Conceptual Review Agenda

Monday, November 17, 2014

255 S Taft Hill Rd Single-Family Home

SITE PLAN

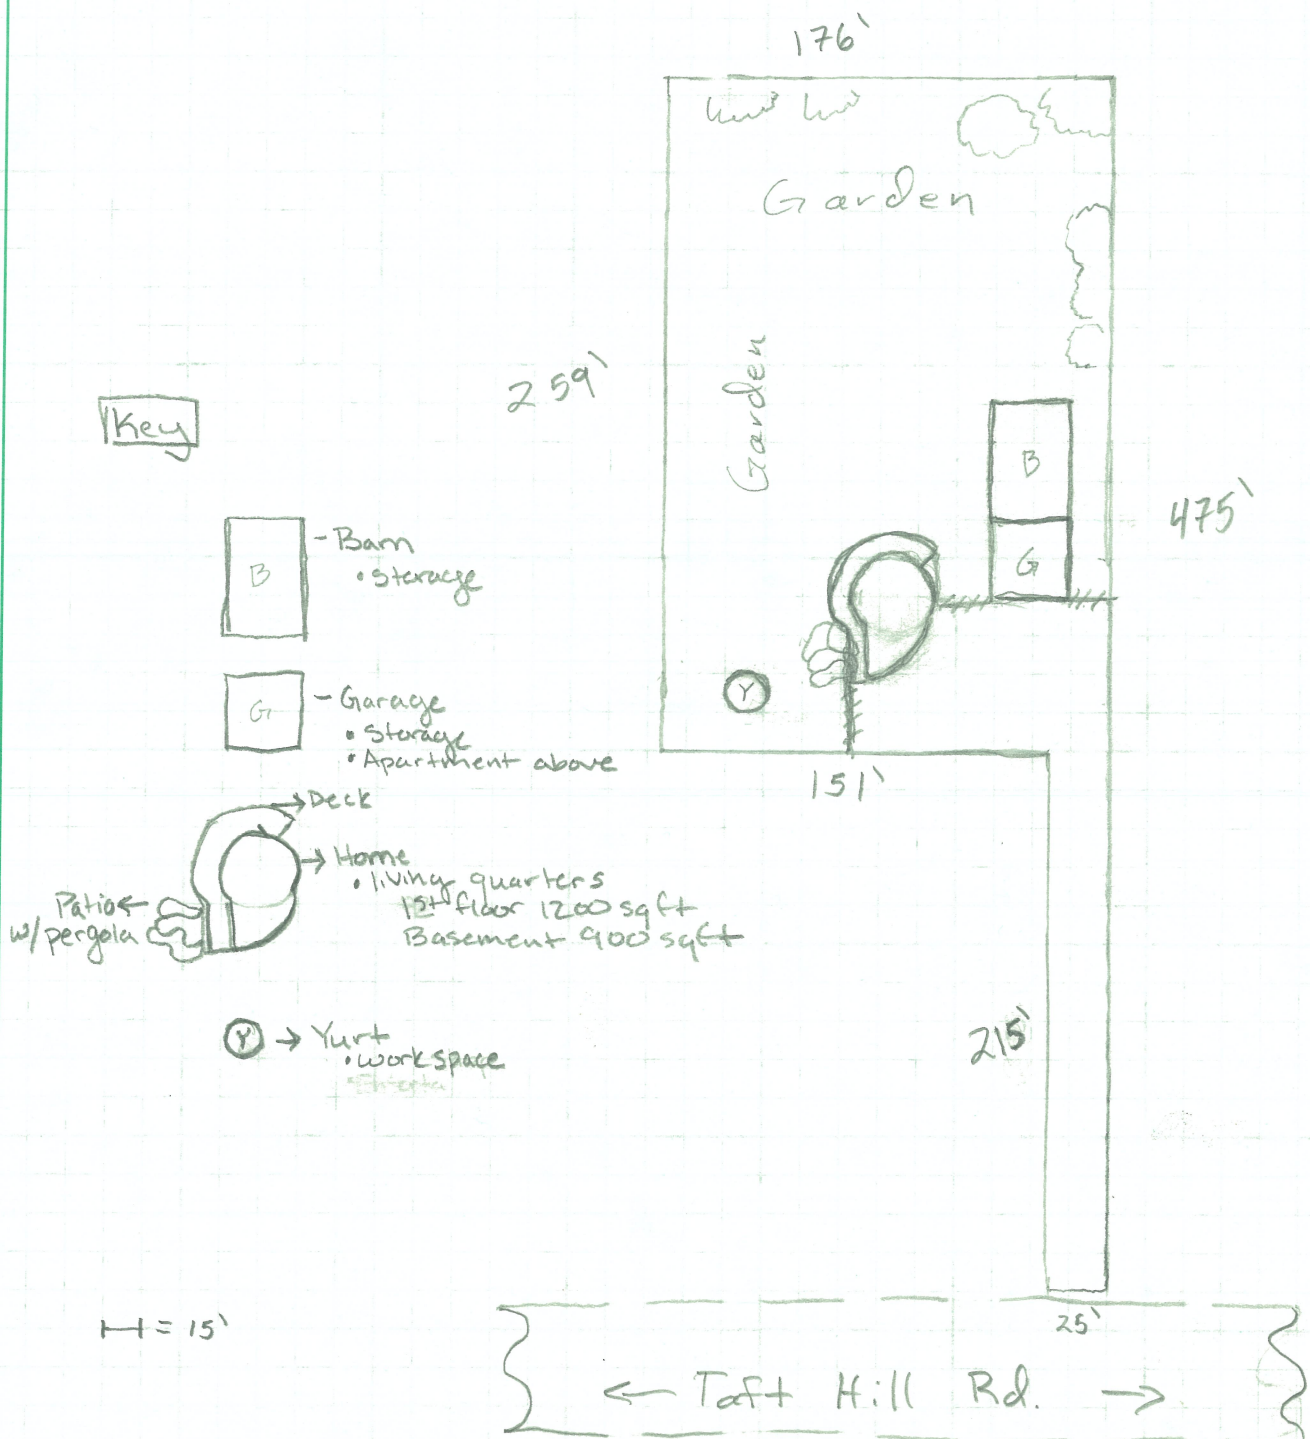
1. 3.5.2(D)(1) - You will likely need to apply for a modification of standards for this provision. This standard calls for a connecting walkway that leads to your front door to be no more than 200 feet away from a sidewalk. Due to the configuration of your lot, this will be impossible to meet and you will likely be eligible to a modification based on hardship.

2. 3.5.2(E)(5) - The accessory buildings on your site may not exceed 2,500 square feet of floor area.
3. 3.8.10 - Since your lot has less than 40 feet of street frontage, you will be required to provide at least 2 off-street parking spaces per dwelling unit. Since you are proposing two dwelling units, you will need 4 parking spots on your site. These spots can be provided in a garage or on an improved area with a permanent border.

N
LYRIC CINEMA
CONCEPT "A"
11.6.14

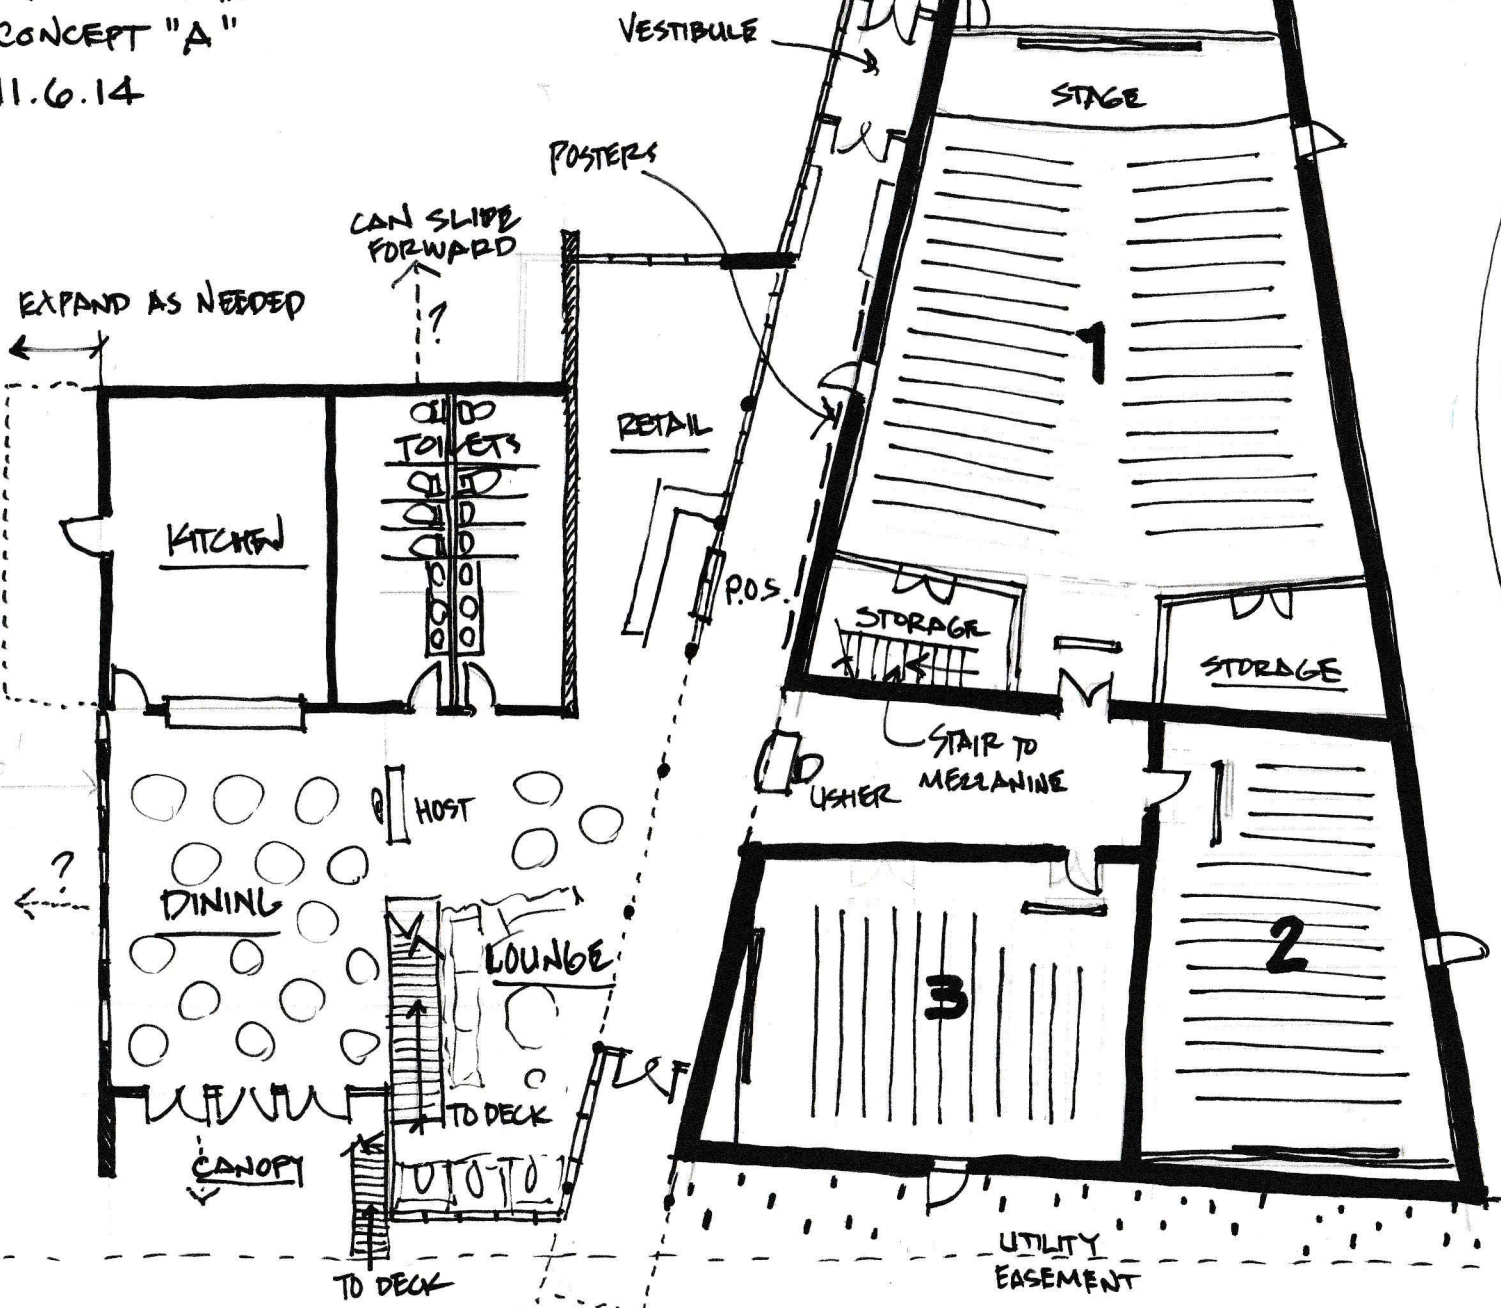
1. If you do provide parking please see Land Use Code (LUC) section 3.2.2(K)(1)(h) for maximum spaces allowed.
2. If you provide parking please see section LUC 3.2.2(K)(5) for Handicap parking requirements.
3. If you provide parking:
LUC 3.2.2(L) Table A and B
Standard 90 degree parking stall is 19'x 9'
Two-way drive aisle is a minimum of 24' in width
4. LUC 3.2.2(C)(b) Theaters have a minimum bicycle parking requirement based on 1/30 seats, minimum of 4 spaces, all of these spaces could be fixed bicycle racks.
5. LUC 3.2.1 A landscape plan is required which includes but is not limited to street trees (see section for further details)
6. If you provide parking:
LUC 3.2.1(E)(5) A minimum of 6% of the interior space of all parking lots is required to be landscaped.
Please show the calculations on how this is being met.

7. LUC 3.5.3 These building design and location standards do apply. At least 30% of the total length of the building along College Ave. must be at least 10 feet and no more than 25 feet from the street right-of-way
8. LUC 3.2.5 All development, to the extent reasonably feasible, shall provide adequately sized conveniently located, accessible trash and recycling enclosures.
- 8.

2. As indicated in the application letter, there are some questions as to the exact location and purpose of the existing Utility Easement. The sewer main was originally installed in 1956 and it is possible there is no formal easement in place. As part of this development, a 30' Utility Easement would need to be dedicated to the City if there is not one already in place. If the existing easement is not centered on the sanitary sewer, it is possible this easement may be for another utility and may require further investigation.

Hydrant spacing and flow must meet minimum requirements based on type of occupancy. A hydrant is required within 300' of the building. Without a scaled site plan for study, it is unclear if this requirement is being met. Code language provided below.
